Harmonizing MPCP Frame Formats

What is Meant by "Harmonizing"

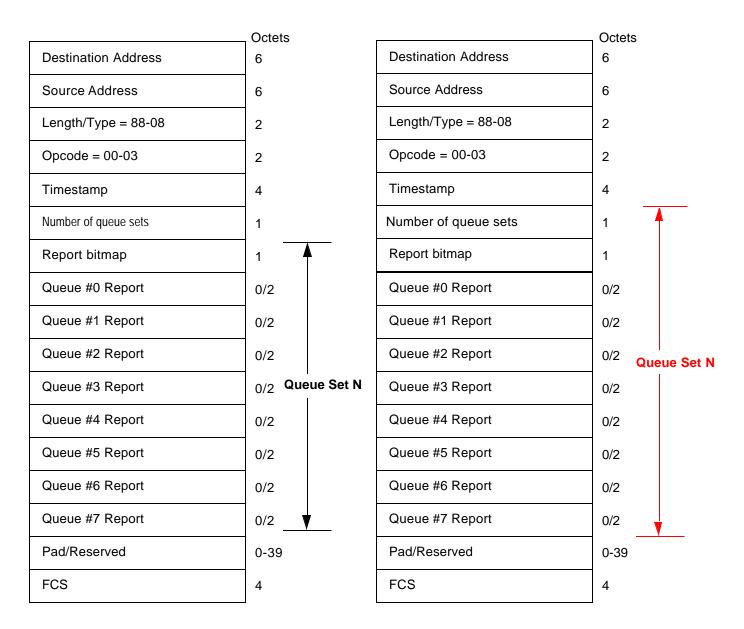
Ramifications to Draft

Changes are minimal to frame formats and minor impact on draft
